Clarifications & Responses Issue 1

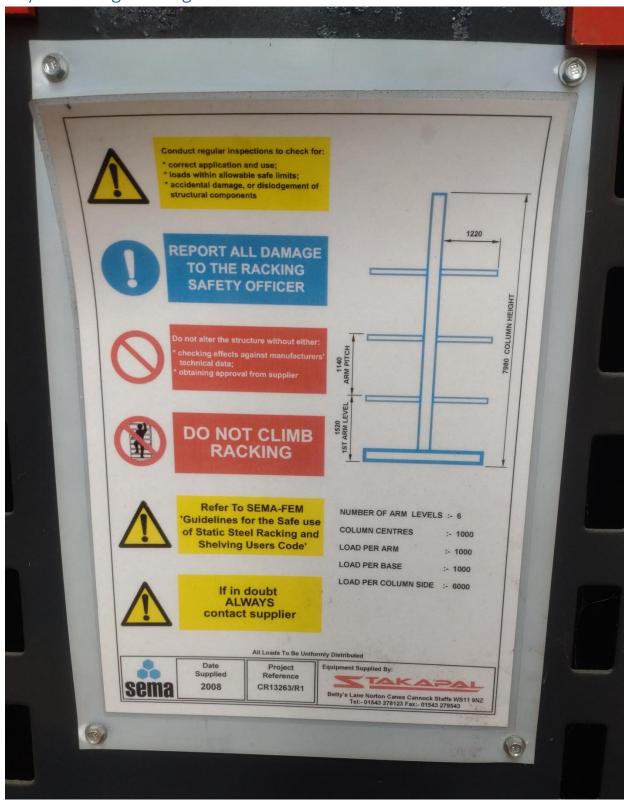
### Q12- Pallet racking in Bay 4 to provide clearance from wall for combi lift?

Pallet racking in Bay 4 to be positioned 500mm from end wall to allow combi lift access.
